# MANN-FILTER

## Product Information

No. 154  
14.01.2020

### **MANN-FILTER C 22 039 will replace the OE-Filters 17801-31131, 1500A608 and 53146541 (Lexus, Toyota und Jeep)**

MANN-FILTER C 22 039

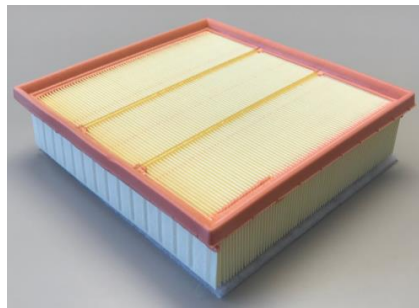
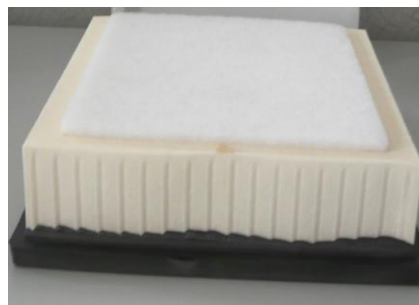
Because of the great filter performance, the new MANN-FILTER C 22 039 is going to replace other OE-Filters. The required original equipment values are mainly achieved by the good filter medium and the pre-nonwoven. This makes it possible to replace the filter for Lexus/Toyota (OE-No. 17801-31131), which is manufactured without pre-nonwoven and without grid, and the filter for Jeep (OE-No. 53146541), which is manufactured without pre-nonwoven but with grid.

Consequently three different filters are covered by one MANN-FILTER product.
